APPLICATION NO.	FILING DATE	FIRST NAMED INVENTOR	ATTORNEY DOCKET NO.	CONFIRMATION NO.
10/500,573	07/01/2004	Hiroshi Aruga	032404-080	4787

Office Action Summary

DETAILED ACTION

FIG. 3

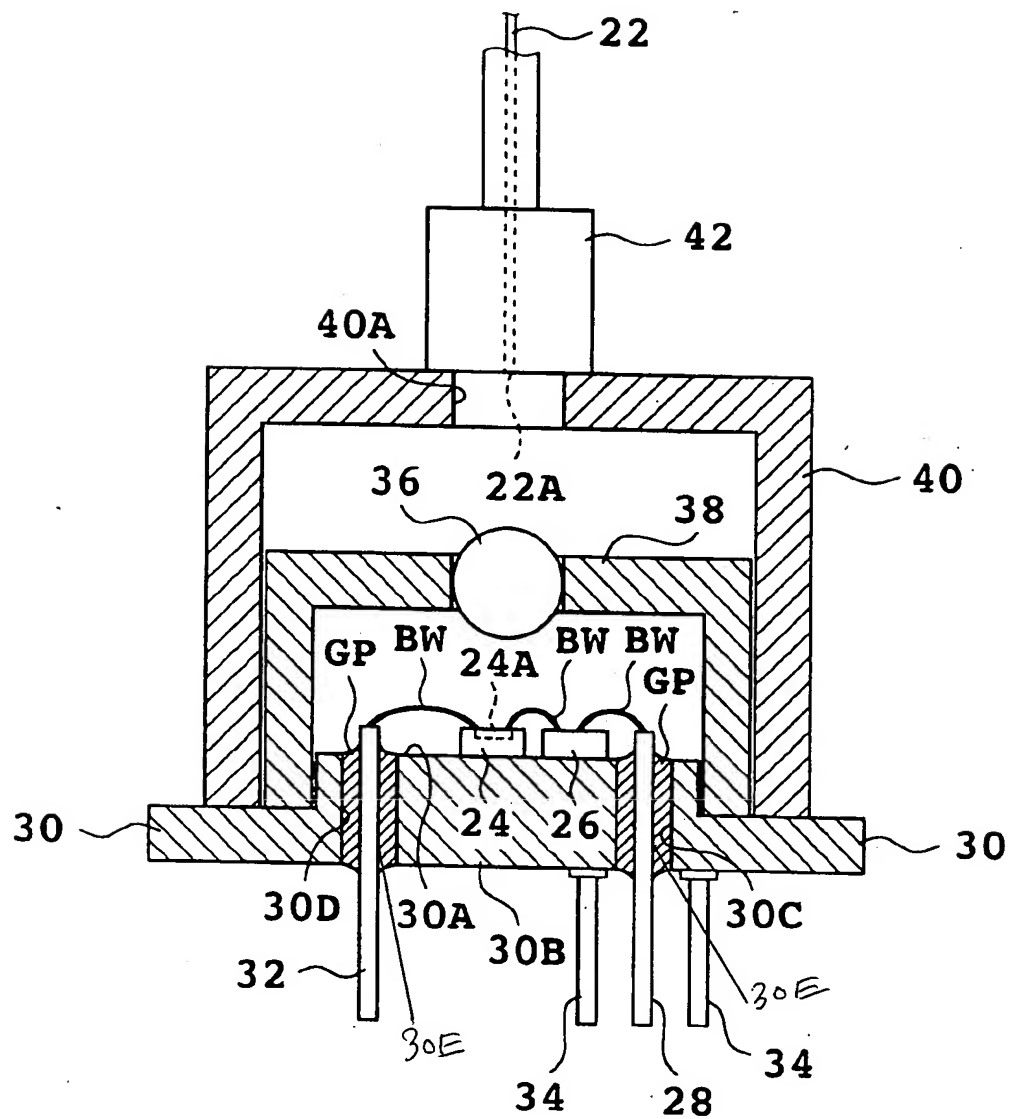
Oikawa discloses an optical semiconductor package that contains an optical semiconductor element 24 and an integrated circuit 26 which transmits and receives differential

signals to and from the optical semiconductor element 24, the optical semiconductor package comprising: a dielectric (GP) sealed into and fixed to a wall surface of the package, and having a pair of pin insertion holes 30E; and a pair of signal pins (28,32) that penetrate through and fit into the pair of pin insertion holes 30E, and constituting differential lines, wherein differential signals are transmitted and received to and from the integrated circuit through the pair of signal pins (28,32). (Note attachment #1, fig. 3 of Oikawa).

With regard to claims 1,2, Oikawa discloses an optical semiconductor package for packaging therein an optical semiconductor element comprising a stem 30 with a hole 30C; a glass dielectric material (GP) sealed into the hole 30C of the stem 30, and with a pair of pin insertion holes 30E; and a pair of signal pins (28,32) that penetrate through and fit into the pair of pin insertion holes 30E of the glass dielectric material (GP), and that constitute differential lines electrically connected to the optical semiconductor element 24. (Note attachment #1, fig. 3 of Oikawa).

Oikawa discloses all the claimed subject matter except for a pair of signal pins (28,32) to be a pair of high frequency signal pins. However, it would have been obvious to one of ordinary skill in the art to form a pair of signal pins to be a pair of high frequency signal pins in order to increase a high-speed operation of the optical device.

With regard to claim 6, Oikawa discloses a ground member 34 in parallel to the pair of the signal pins (28,32) is provided on the stem 30. (Note attachment #1, fig. 3 of Oikawa).

With regard to claim 11, Oikawa discloses a cap 40 that includes a light passing hole 40A and that airtight closes an internal space including the optical semiconductor element 24 by fixing an end portion to the stem 30. (Note attachment #1, fig. 3 of Oikawa).
